**In the Matter of:**  
**PR Spring Tar Sands Project**  
**February 15, 2011, Ground Water Discharge Permit-by-Rule**

**INDEX OF INITIAL RECORD**

**January 10, 2012**

FIGURE 2a  
 GENERAL ARRANGEMENT OF OVERBURDEN  
 STORAGE AREA AND SAND TAILINGS  
 ENCAPSULATION CELLS

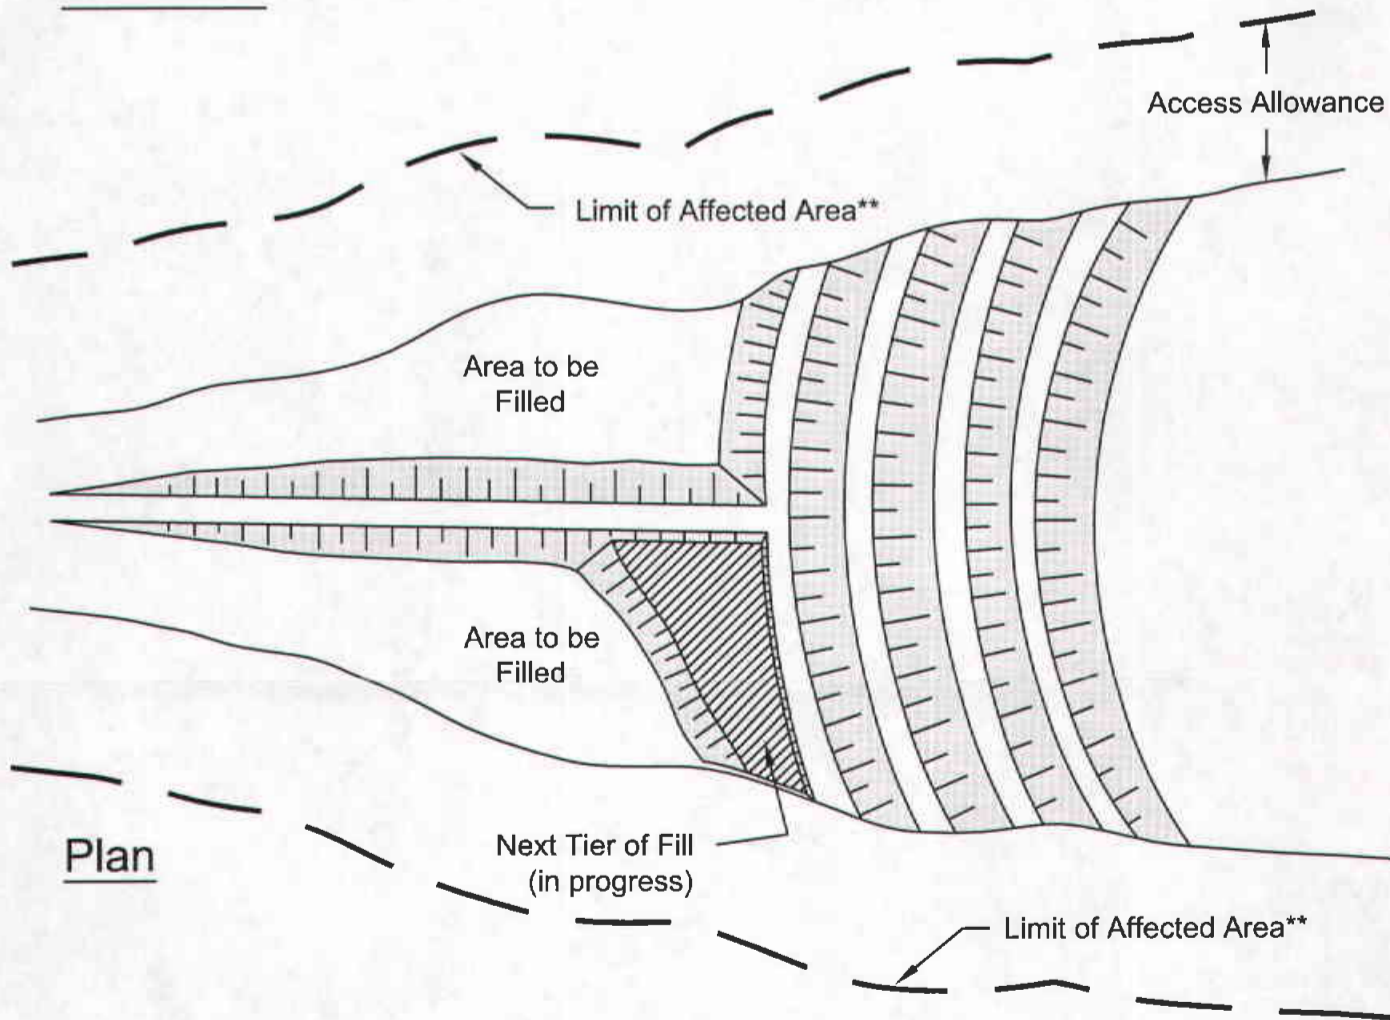
Comment #	Sheet/Page/Map/Table #	Comments	Initials	Review Action
	Figure 2a / Page 20	Figure 2a and paragraph 4 say the containment "cells will not be constructed on slopes greater than 20 percent (11 degrees)" yet Figure 2a notes "maximum of 20 degrees slope at the toe." Please correct or clarify the text or figure to reflect slope stability model that used for mine planning from the engineer of record.	lah	Figure 2a has been corrected.
	General	It is DOGM's recommendation that slope designations (percent, degrees or horizontal:vertical) are consistent throughout the document.	lah	Thank you for the recommendation. No change has been made to the plan at this time.
	Figure 2a	Upper drawing, berm should not be shown as the same material as the sand tailings.	lah	Figure 2a has been revised.

9	Figure 2a	Overburden should be keyed into natural slope for stability FOS (lah)	B	Earth Energy mine engineers do not feel that it is necessary to key overburden in to the slopes in all locations or as a matter of general design. However, on the steepest areas of overburden placement, the toes of fills may be keyed into existing slopes as deemed necessary in the field at time of placement; a statement to this effect has been added to the NOI, but figure changes have not been made. Also see the response to Comment #51, which discusses the conservative nature of the overburden/interburden storage area design.
10	Figure 2b	Include either plan view of feature or more description of where feature will be used. Where will a unlined ditch be used as opposed to a rip rap lined ditch, where will the berm be used in the plan (lah)	B	Earth Energy does not believe that a plan view of a typical berm or a typical ditch is needed; the cross sections provided in Figure 2b are fully understandable and these features are common, typical, and standard. Cross sections are a standard way to describe such structures. In regard to exactly where they will be used, and additional descriptions, please see changes that have been made to pages 16 in Section 106.2 in the current version of the NOI.

**Earth Energy Resources**  
**Figure 3**  
**PR Spring Plant Site - Plot Plan**  
**Preliminary Equipment Layout - Rev.4**

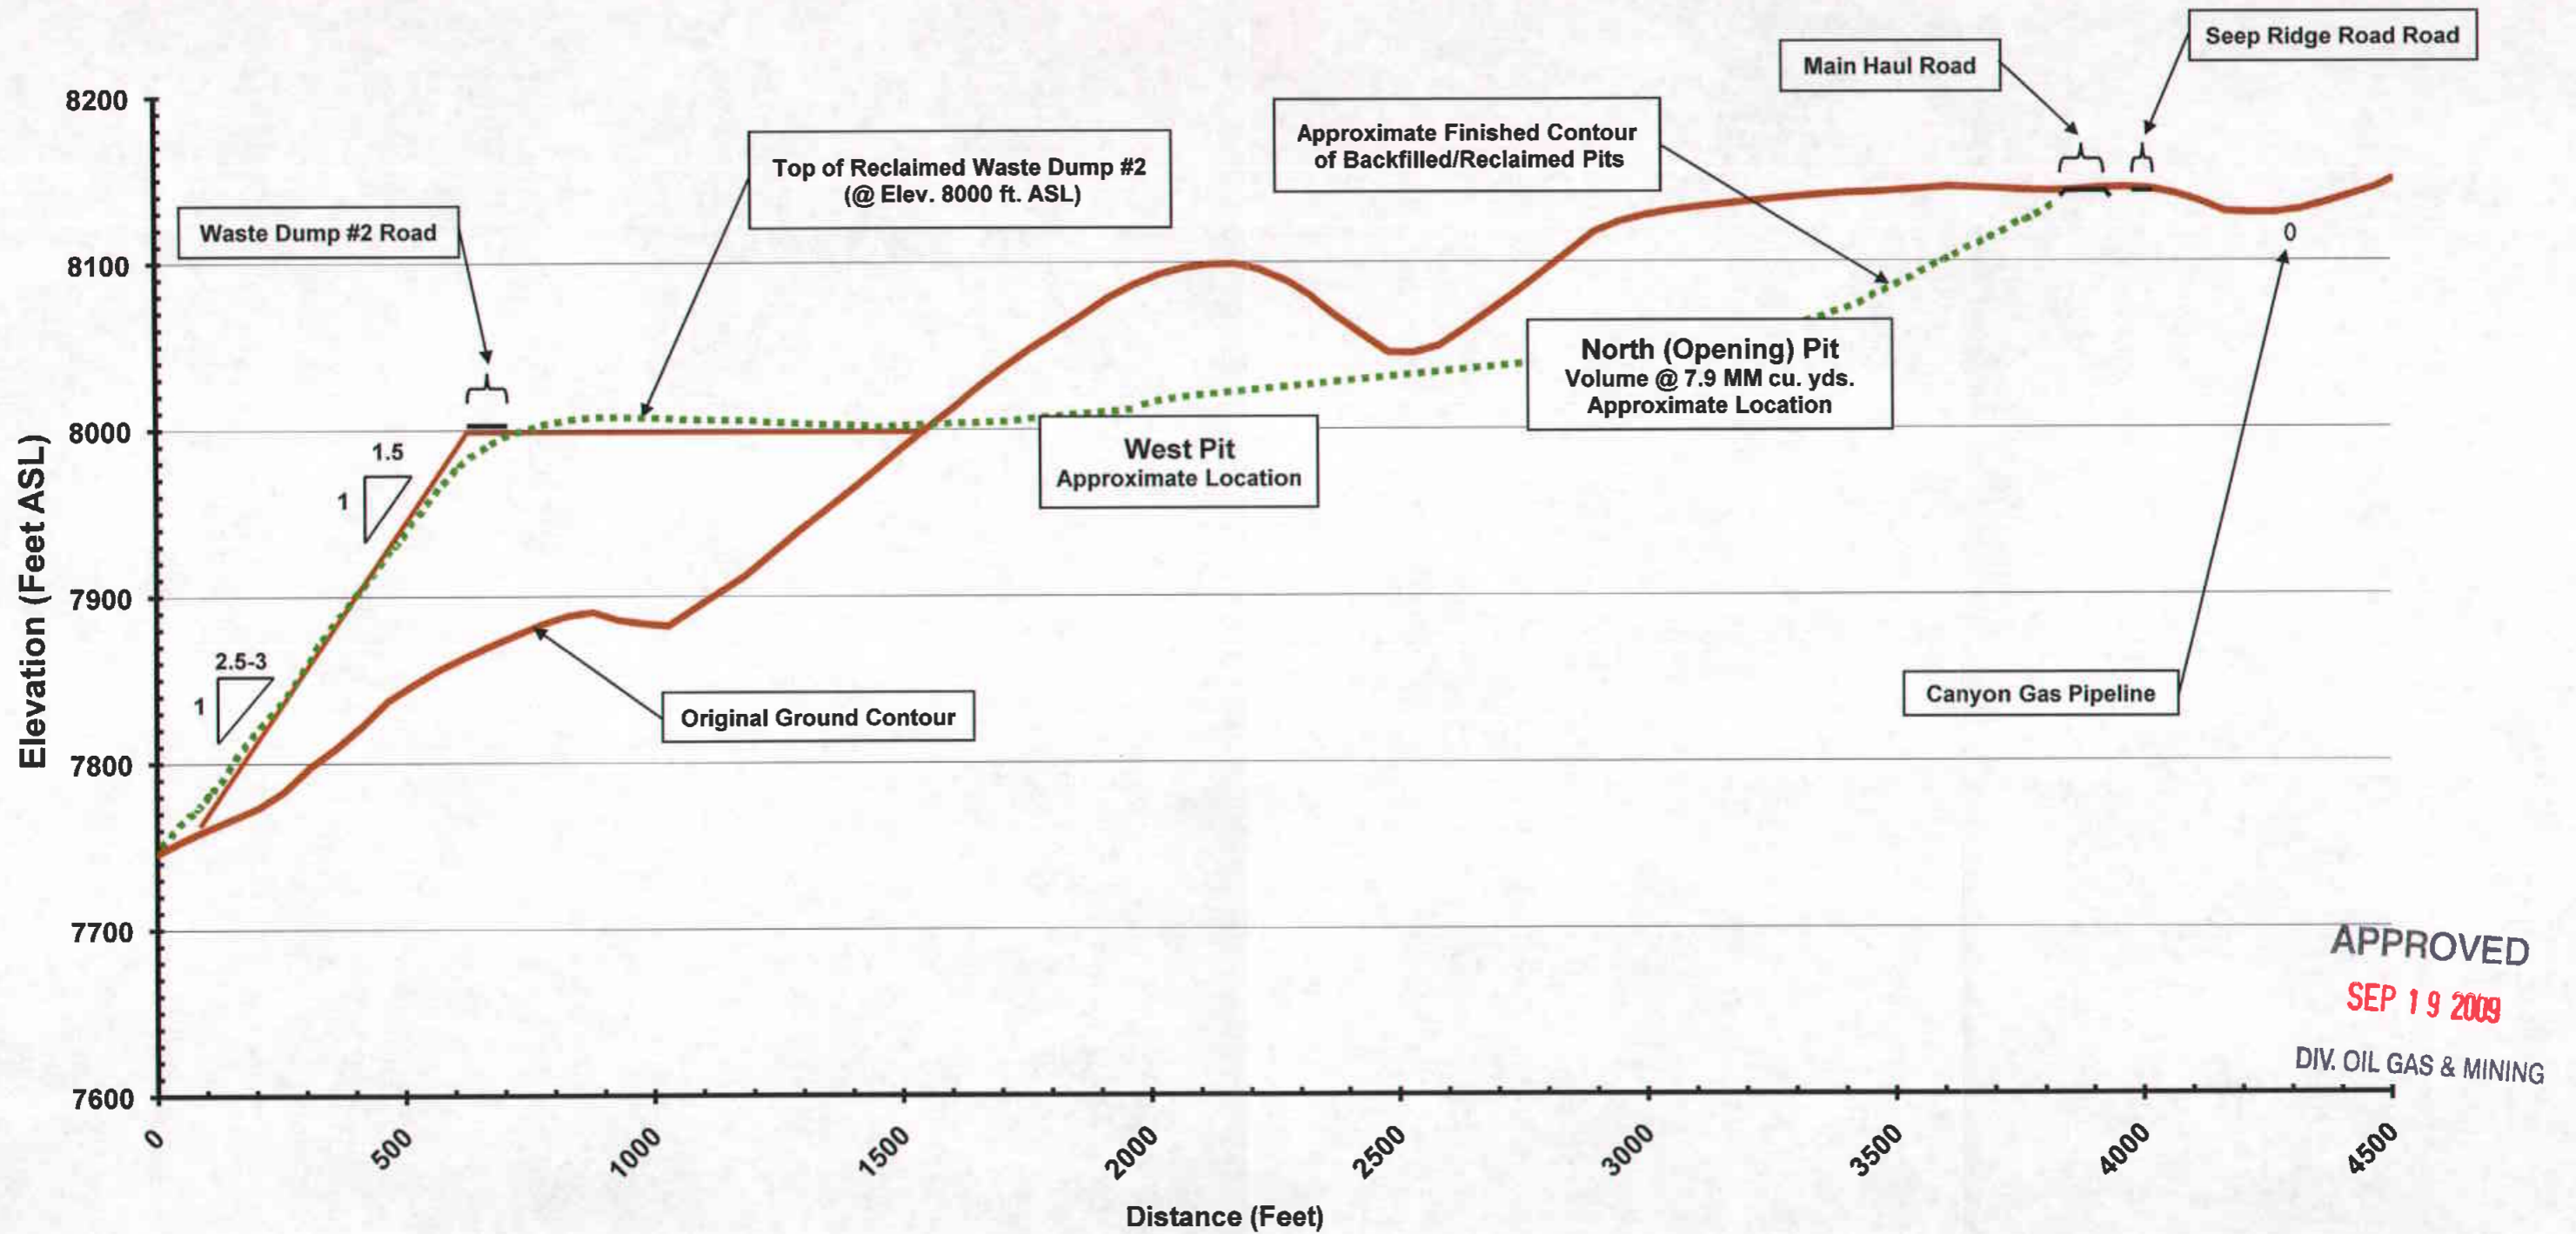
Figure 3	Define 203 acres listed in text and in bonded area. (lah)	B	Please see the response to Comment #6. Also note that acreage values have been refined throughout the current version of the NOI.

Comment #	Sheet/Page #	Comments	Review Action	Earth Energy Responses
12	Figure 3	Label figure 3 - features to be tied to surety bond (lah)	A	There is no good way to add all of the surety information onto this figure. The surety table includes references to these features and the assumptions used therein and does not need to be duplicated on this figure.
13	Figure 3	The facilities map should include the dimensions of the buildings, ponds, piles etc. These dimensions can be part of the legend and referenced appropriately. The map should show roads, including access and haul roads; utilities and power lines (water, gas, power, telecommunications etc); and drainage control devices. (BE) Maximum size of the facilities are needed for bonding calculation purposes. (lah)	A	Earth Energy respectfully disagrees that dimensions should be placed on Figure 3 for every specific structure, for the following reasons. First, with the additional labeling already added to this figure in response to Comment 12, the figure is simply too cluttered to contain the additional information. Second, the figure is meant to represent the conceptual plans for the surface facility, as they are currently known; detailed engineering designs have not yet been prepared and Earth Energy has committed to submit those detailed designs, which will include dimensions, once they are available. Third, the figure as is contains overall site dimensions, from which the relative and general sizes of the specific features within the site can be generally and easily inferred. Last, Earth Energy recognizes that dimensions are important for surety purposes; to that end, the bond calculation worksheets spell out the presumed maximum sizes for specific structures.
